Comment Resolution Status

Document: T10/1415-D revision 11

To: T10 Committee Membership
 From: Cris Simpson, Intel Corporation
 Subject: Response to T10 Letter Ballot comments on SRP

Figure 0.1 - IB I/O unit example

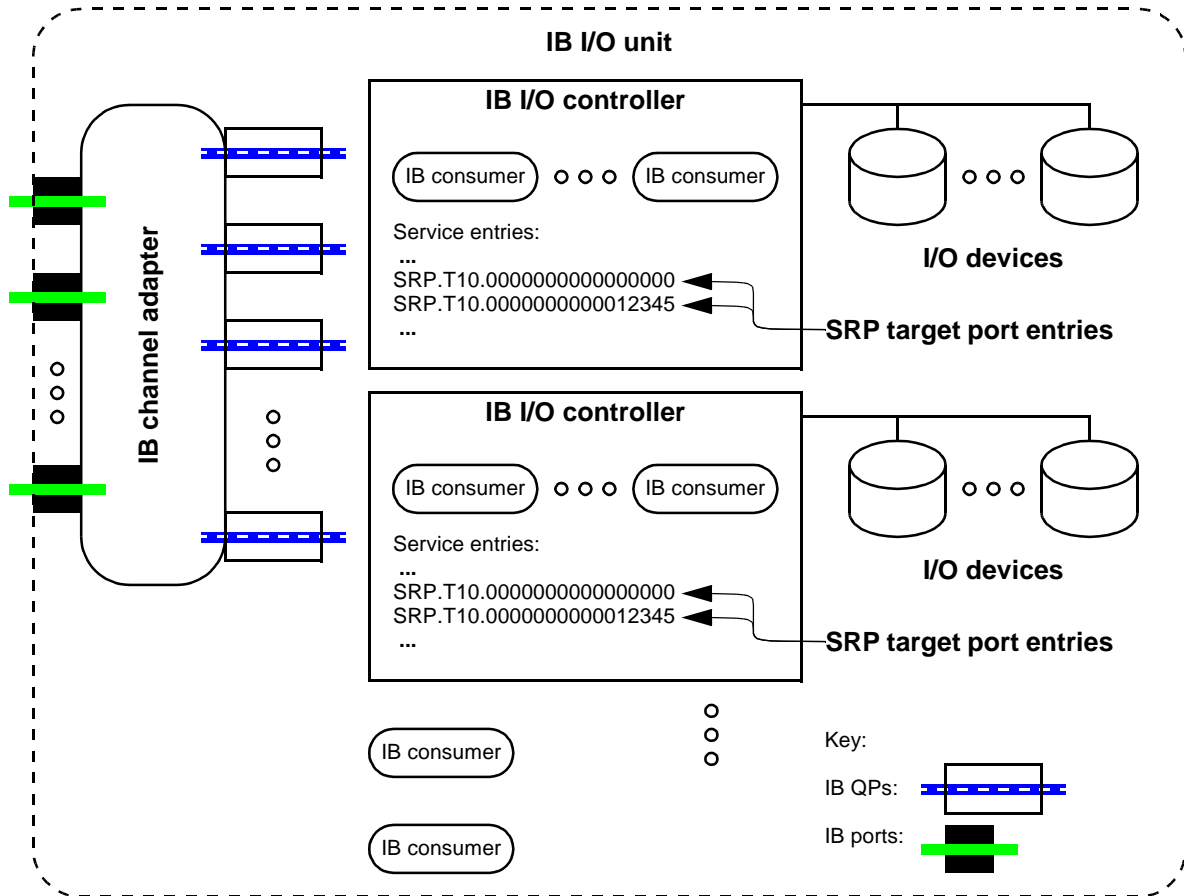
Figure B.3's equating of 'SRP Target Ports' with 'IB consumers' is problematic. A 'target port' is a sort of service access point---somewhere where interested parties initially go to obtain service, but without any implication that that's where the service is actually provided. (In IB, it's the Connection Manager that receives the initial connection request, interprets the ServiceID contained therein, and performs some magic that results in the instantiation of a QP bound to some entity that actually provides the target services). This target-services-providing entity fits the definition of 'IB consumer'. But the mapping of ServiceIDs-cum-SRP target ports onto such entities is clearly a matter of implementation, and could be one-to-many, many-to-one, or many-to-many Suggested Solution: One possibility: to the left of the IB Consumers show a table/list of service IDs within each IB I/O unit and label these entries as SRP Target Ports; use arrows to show a mapping from the entries to the IB Consumers, with e.g. one Consumer mapped to two IDs and another mapped to one ID to show that the mappings are not always 1 to 1. A further refinement might be to use another set of arrow between the Consumers and the QPs to show that the this mapping is also not 1 to 1

This comment is correct, but it's not immediately obvious how to incorporate it into a legible diagram. Note the further complication introduced by connection redirection. The IB consumer (IB QP and the software, etc. behind it) may be in an unrelated device / node / whatever, it need not be the same channel adapter or even an I/O unit. The sole purpose of the I/O unit and I/O controller is to obtain a service ID, connecting to that service ID may lead somewhere else altogether.

Notes from 28 Nov 2001 teleconference: show service entries in figures B.2 and B.3, in accompanying text explain that each service entry identifies an SRP target port.

The following is an attempt at a modified figure B.2 and the text describing service entries that identify SRP target ports

Figure 1 - SCSI document relationships

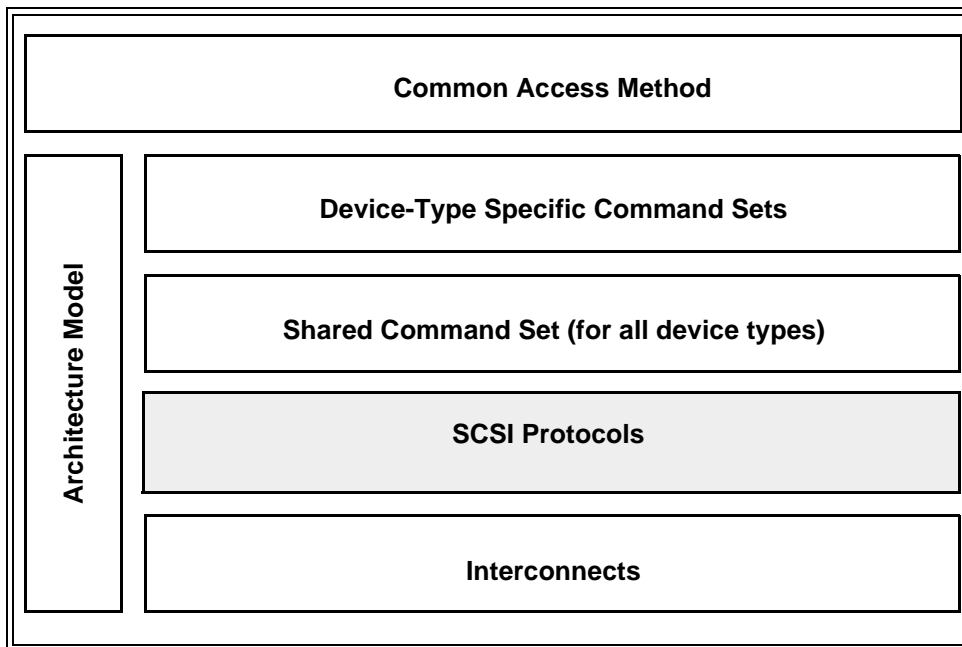
Delete CAM from figure 1 Delete these SCSI-2 standards from the example standards list:
Serial Storage Architecture SCSI-2 Protocol SSA-S2P [ANSI X3.294:1996] Common Access Method: SCSI Common Access Method CAM [ISO/IEC 9316-421] [ANSI X3.232:1996]
The 28 Nov 2001 teleconference voted that this be accepted.

"Figure 1 shows the relationship of this standard to the other standards?" But it doesn't. The SRP standard is not identified in the figure. Despite the disclaimer, layering of the blocks does suggest a hierarchy, protocol stack and system architecture. But the figure does not indicate the applicability of SRP to the implementation of a SCSI transport, as far as I can tell.

Figure 3 - Example RDMA channel establishment

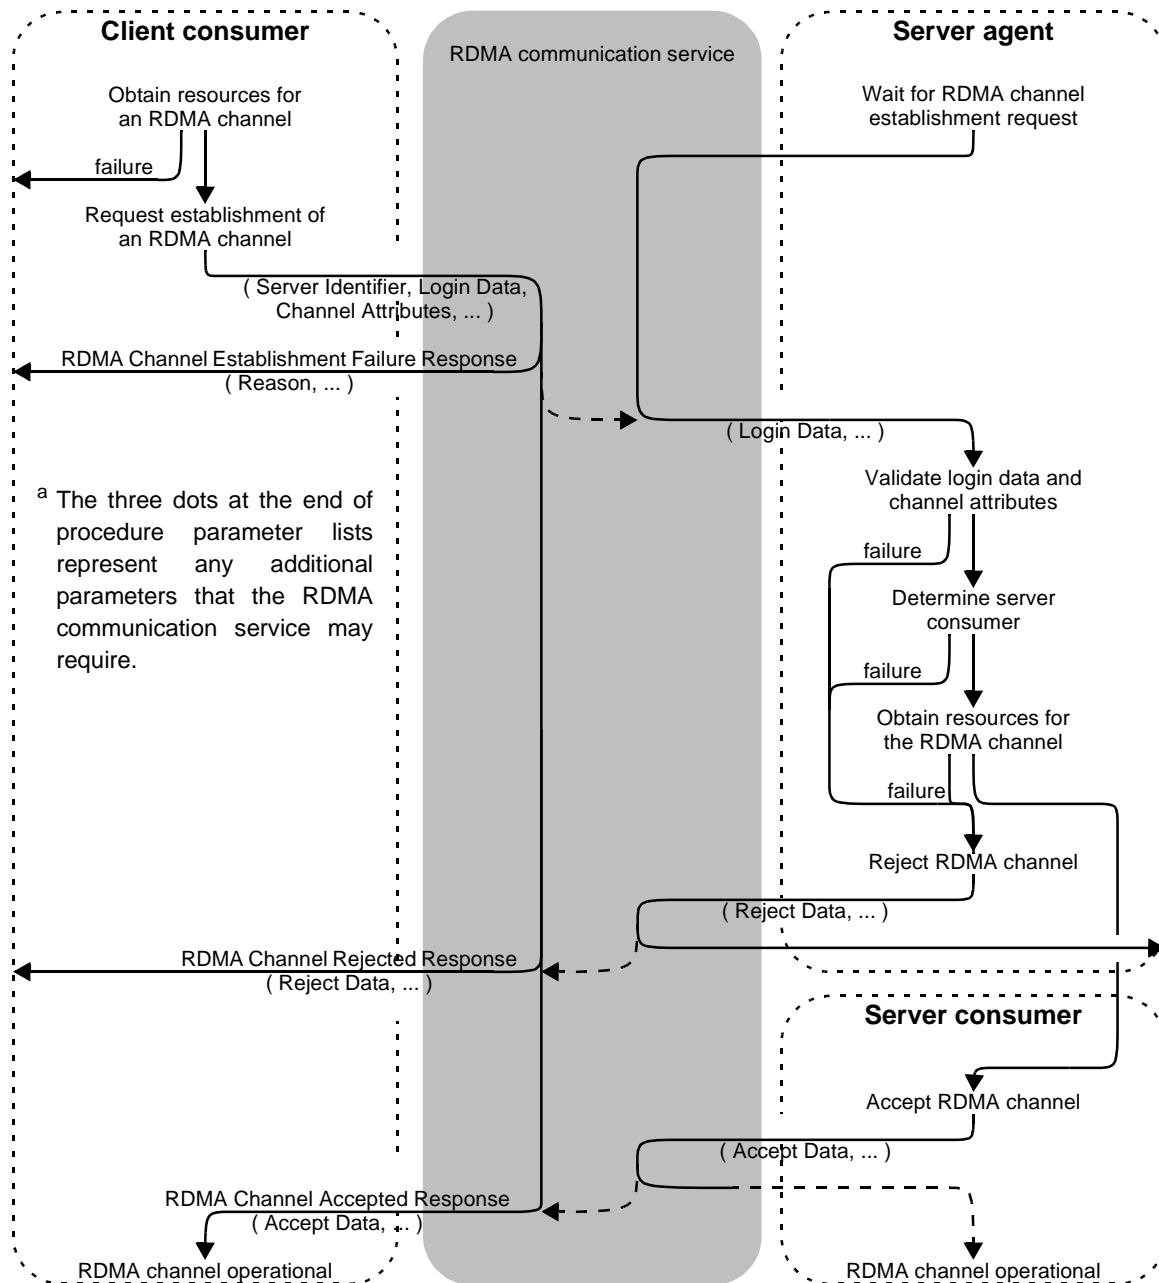
Page 9 - Figure 3 - line 40 - The arrow exiting to the right seems to dead end. Where does the flow go from there. All the other exit points are clear that one is not.

Figure 4 - Memory descriptor mapping

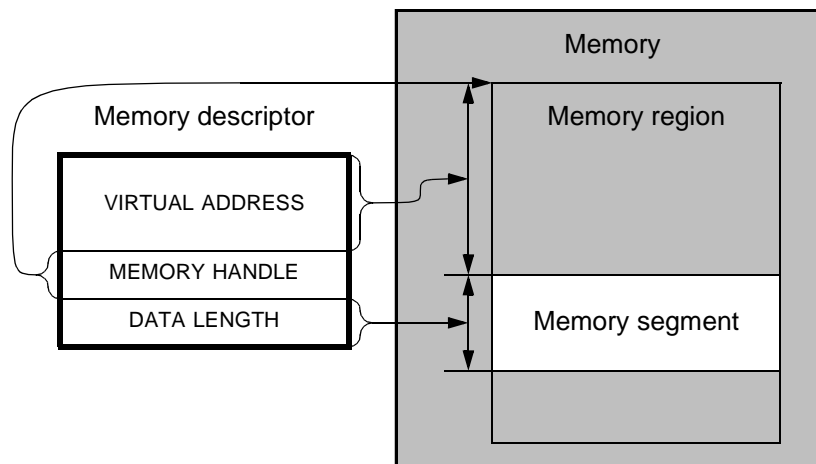
Page 17 - Figure 4 - The way the arrows are pointing for the virtual address implies that it is not the address of the first byte of the memory segment. It currently implies that it is the space from the memory handle to the beginning of the memory segment which is the memory region. It is also not clear as to what the boundaries are of the memory region. The current drawing implies it is only the area above the memory segment. I do not believe that is correct so it needs to be fixed.

Figure A.2 - Model for a four step confirmed service

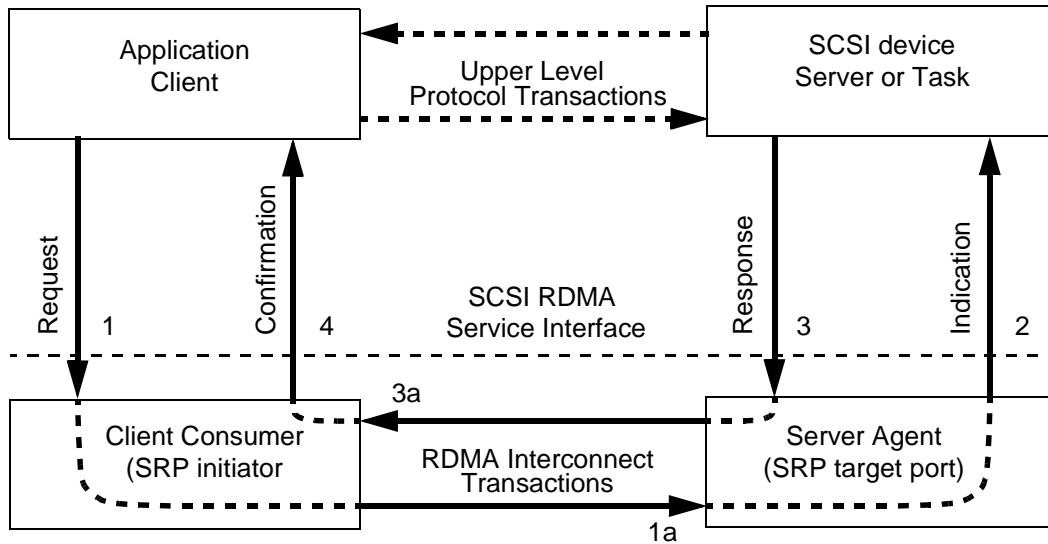
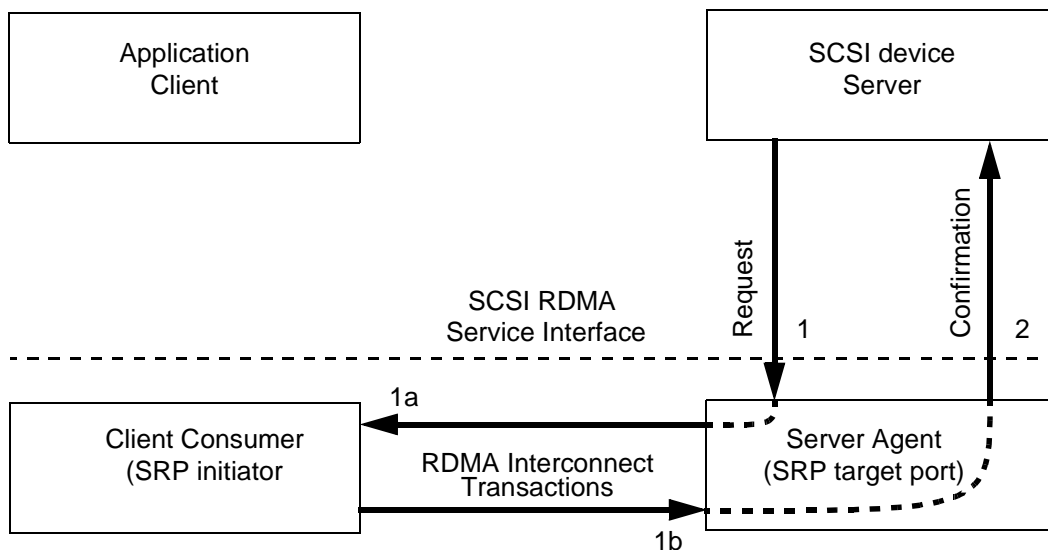
Page 46 - figure A.2 and A.3 - line 15 and 43 - The statement '(SRP initiator' should be '(SRP initiator port)'

Figure B.2 - IB I/O unit example

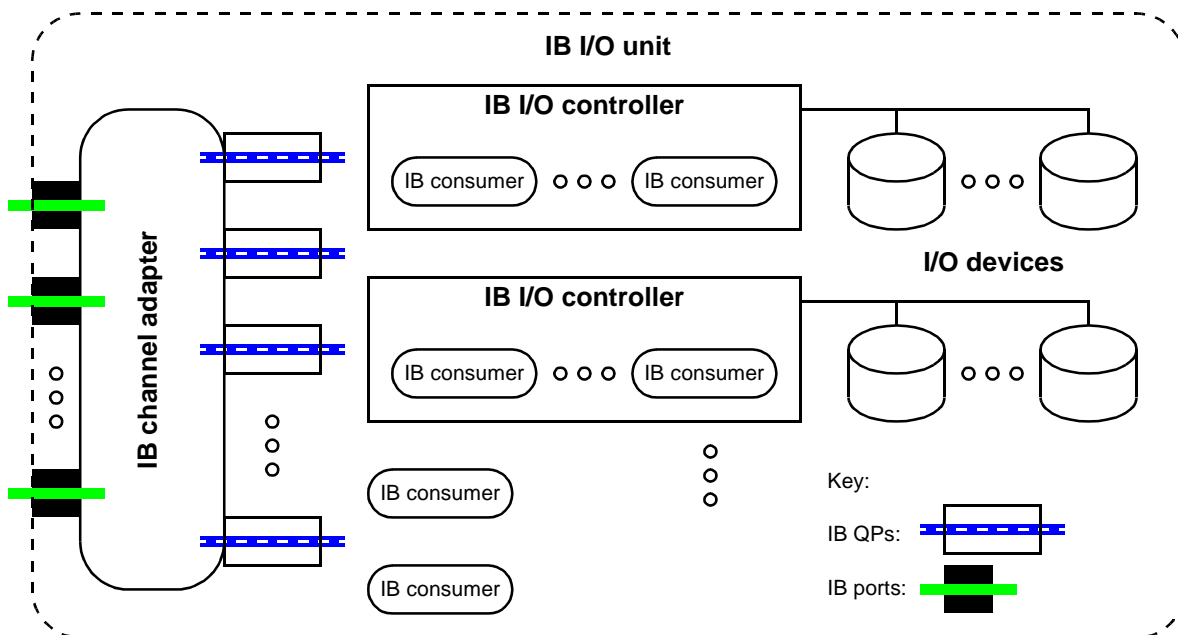
Figure B.2. Can I/O controllers be virtual objects?

Figure B.2. What is the purpose of allowing multiple IB consumers per IB I/O controller? Is it so that multiple IB connections can be terminated within an IB I/O controller? (This relates to the question above about correspondence between QPs and IB consumers.)

Figure B.2. How are shared LUs modeled? Do SRP target ports contain the "task router" function described recently by Penokie? Can two IB I/O controllers have an underlying LU in common, or is this functionality restricted to two IB consumers within the same IB I/O controller?

Figure B.3 - SCSI architecture mapping

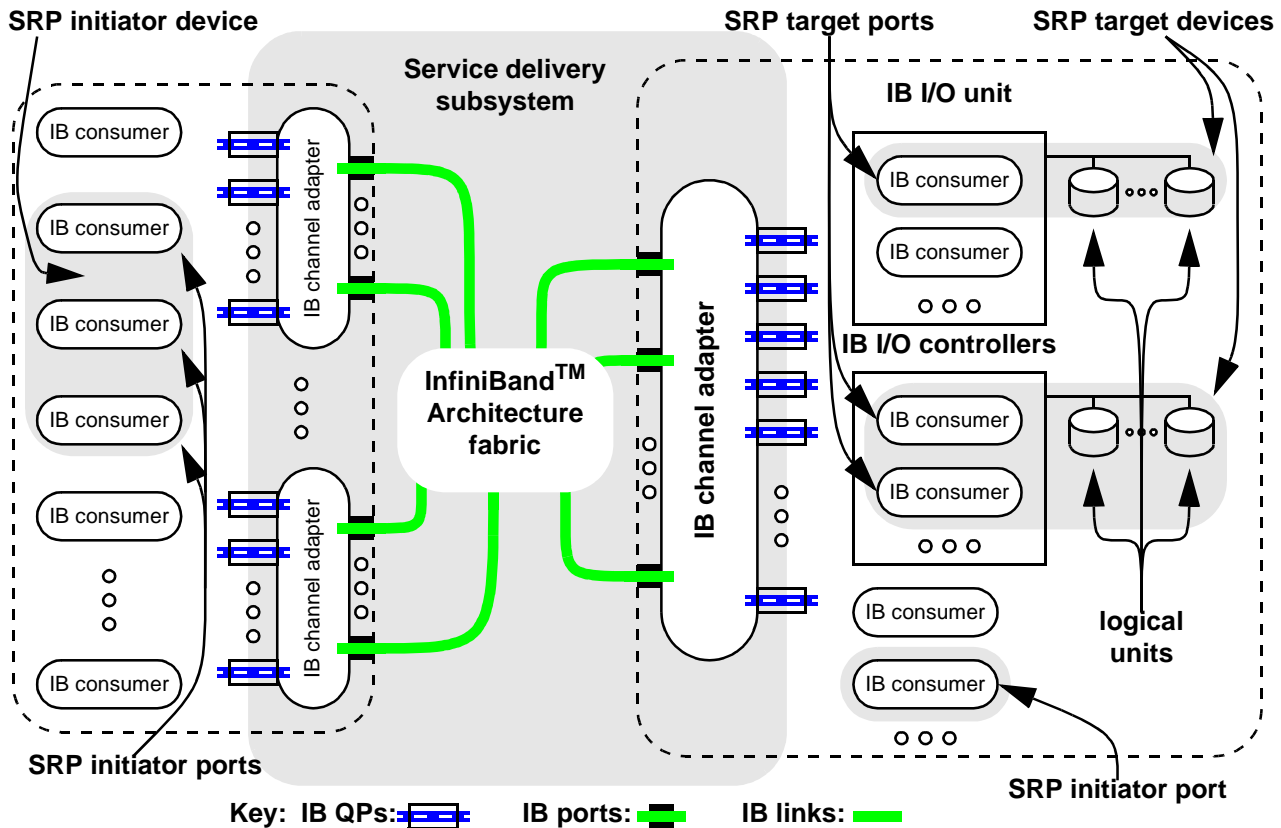
Figure B.3. What is the object indicated by the dashed lines in the initiator model, analogous to the IB I/O unit in the target model?

Figure B.3. and 56-1. Table B.2. The rules for constructing initiator ports seem entirely too lax. The text says, "Initiator port identifier should be constructed?" And then the Table indicates that GUID, for example, is the channel adapter GUID. Is there no meaning associated with the initiator port ID? Is the only design goal that the 16B port ID be globally unique? Will any GUID do at all? If so, let's be explicit about this, and **let's not make any suggestions about the origin (and possible meaning) of the port name.**
